Work Order ID 148096

Item ID: D3016-15 Accept ***N900040100*** Setup Start ***NS1***
 Revision ID: Stop ***NS2***
 Item Name: Gusset
 Start Date: 7/13/2016 Start Qty: 6.00 ***6*** Cust Item ID:
 Required Date: 7/15/2016 Req'd Qty: 6.00 ***6*** Customer:
 Reference:

DESIGN <i>CP</i>	DRAWN BY <i>CP</i>	DART AEROSPACE LTD HAWKESBURY, ONTARIO, CANADA	
CHECKED <i>#</i>	APPROVED <i>#</i>	DRAWING NO. D3016	REV. A SHEET 1 OF 3
DATE 01.05.18		TITLE SEAT FRAME ASSEMBLY	SCALE NTS
A	01.05.18	NEW ISSUE

DRAWING NO. D3016	TITLE SEAT FRAME ASSEMBLY	REV. A	DART AEROSPACE LTD ENGINEERING ORDER	D.E.O. NO. D3016-A-1	SHEET NO. SHEET 1 OF 1	SCALE NTS
DRAWN <i>1</i>	CHECKED <i>UP</i>	MFG. APPR. <i>R</i>	APPROVED <i>W</i>	DE APPR. <i>W</i>		
DATE 10.01.29	DATE 10.01.29	DATE 10.01.29	DATE 10.01.29	DATE 10.01.29

D3016-11 SADDLE

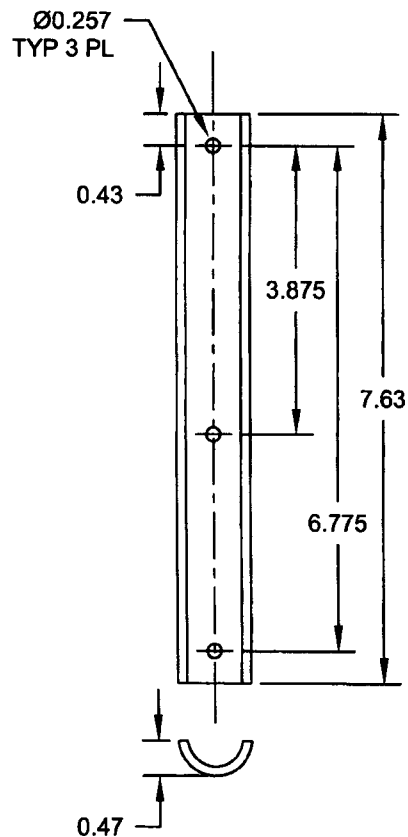
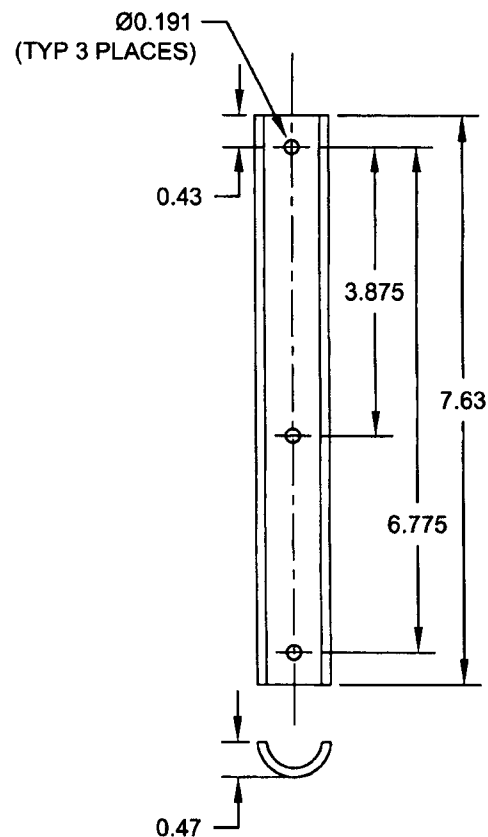
TO REVISE D3016-11 SADDLE'S HOLE SIZES

DETAIL D3016-11 SADDLE (SHEET 3): Ø0.257 TYP 3 PL WAS Ø0.191 (TYP 3 PLACES) AS SHOWN:
